**Tyre Pressure Monitoring
Amendment to R141
Illustration of communication cases**

Volvo Group- Product regulation. D.Caux October 2020

2 - Tractor with TPMS / ISO 11992

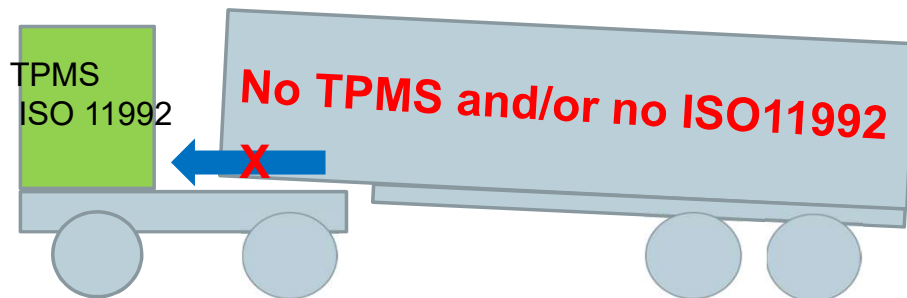
Driver info	Legal aspect (§ 5.4.3, 5.5.5)
a- No	Trailer too old, no TPMS : OK *
b- No	Trailer under TPMS /no 11992 Not OK
c- Yes	Trailer under TPMS with 11992 OK

- * No information to the driver that the case is OK.
- Malfunction warning?

3 – 2 trailers+ dolly, 1st with TPMS using ISO 11992

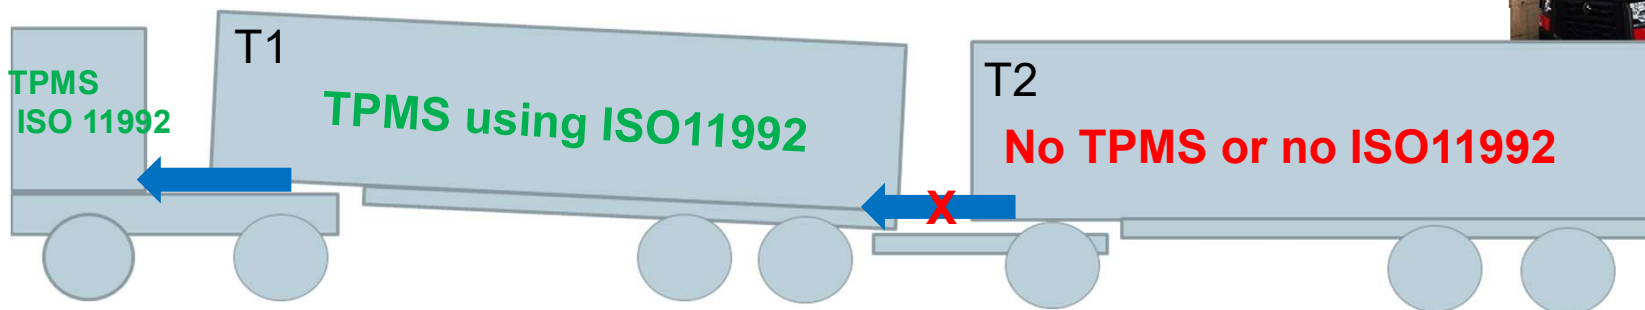
Driver information	Legal aspect
a- Yes, from T1	If no TPMS in Trailer 2 too old : OK *
b-Yes, from T1	If T2 is under TPMS reg. but no ISO 11992 : Not OK *

* **Warning** : the driver has no idea about the status of Trailer 2: he receives info from T1

Warning 2: check the status of the dolly

4 – 2 trailers+ dolly, 1st trailer without TPMS and/or without ISO11992

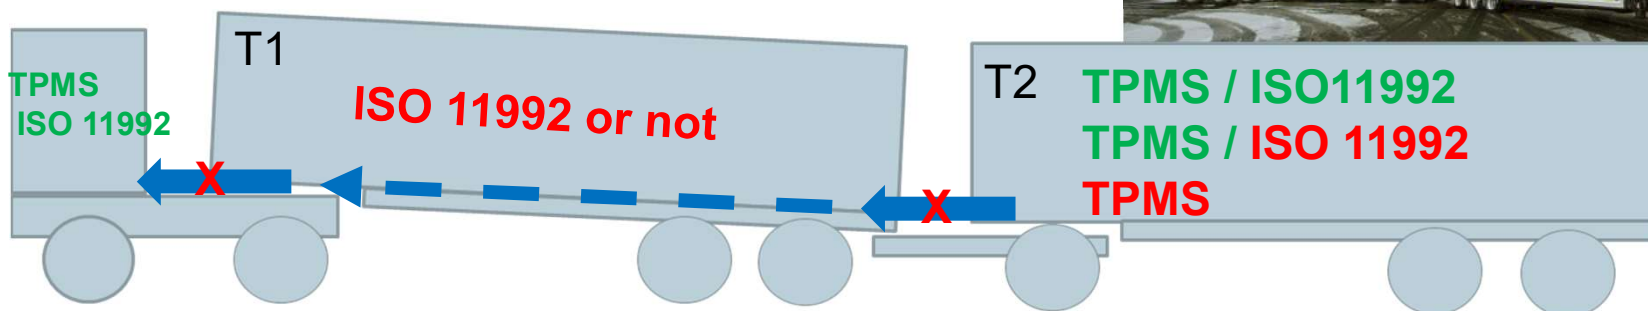
Driver info	T1		Legal aspect
a- No	No 11992	T1 old. T2 old	OK *
b- No	No 11992	T1 old. T2 under TPMS reg	No transmission. Not OK *
c- No	No 11992	T1 under TPMS reg	No transmission. Not OK *
d- Yes	11992 / no TPMS	T1 old .T2 with TPMS and 11992	Messages for T2. OK
e- No	11992 / no TPMS	T2 TPMS with no 11992	No messages. Not OK *

* **Warning** : In case the driver has no info, he has no idea if the situation is legal or not
